Access Compliance Report

Public Rights-of-Way

(Curb Ramps)

Intersection ID: 3295	Main Street: CANTERBROOK_DR	Cross Street: DUNFIELD_CT	Location: SW
ADA ID: 6DD2FE598B20	Ramp Type: Perp	Initial Pass/Fail: Fail	Overall Compliance: No
Severity Score: 10			
Codes/Mitigation Info/Possible Solution		Field Measurements/Component Compliance

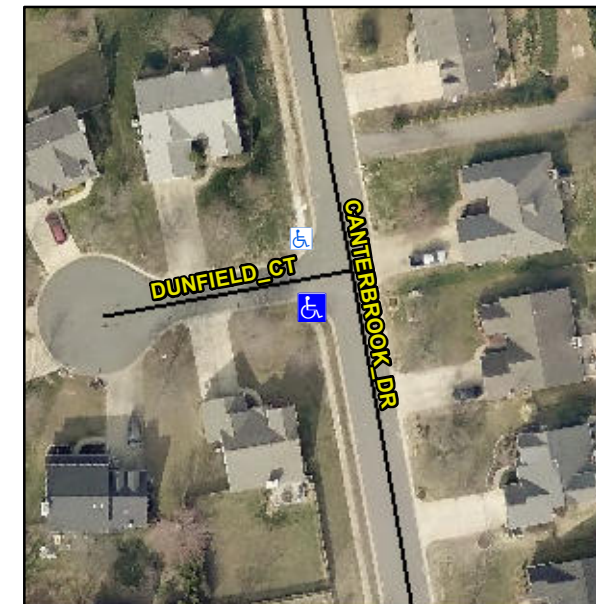
Not Found, R304.5.1, R304.5.3

Compliance	Description	Data	Compliance	Description	Data
N/A	Ramp Length (in)	49.0	Yes	Ramp Slope (%)	5.1
No	Ramp Width (in)	47.0	No	Ramp XSlope (%)	3.1
N/A	Flare Type LT	N/A	N/A	Flare Type RT	N/A
N/A	Flare Slope LT (%)	N/A	N/A	Flare Slope RT (%)	N/A
N/A	Flare Traversable LT?	N/A	N/A	Flare Traversable RT?	N/A
N/A	Landing Length (in)	N/A	N/A	DWS Provided?	N/A
N/A	Landing Width (in)	N/A	N/A	DWS Contrast?	N/A
N/A	Landing Slope (%)	N/A	N/A	DWS Length (in)	N/A
N/A	Landing X Slope (%)	N/A	N/A	DWS Full Width?	N/A
N/A	Landing Curb? (Y/N)	N/A	N/A	DWS Offset (in)	N/A
N/A	Shared Landing?	N/A			
N/A	Gutter Ponding?	Yes	N/A	Gutter Slope (%)	N/A
N/A	Gutter Lip Ht (in)	N/A	N/A	Gutter X Slope (%)	N/A
N/A	Painted X Walk1?	No	N/A	Painted X Walk2?	N/A
	X Walk 1 Direction	To N		X Walk 2 Direction	N/A
N/A	X Walk 1 Width (in)	N/A	N/A	X Walk 2 Width (in)	N/A
	X Walk 1 Slope (%)	2.1		X Walk 2 Slope (%)	N/A
	X Walk 1 X Slope (%)	1.0		X Walk 2 X Slope (%)	N/A

Remove & Replace Entire Ramp.
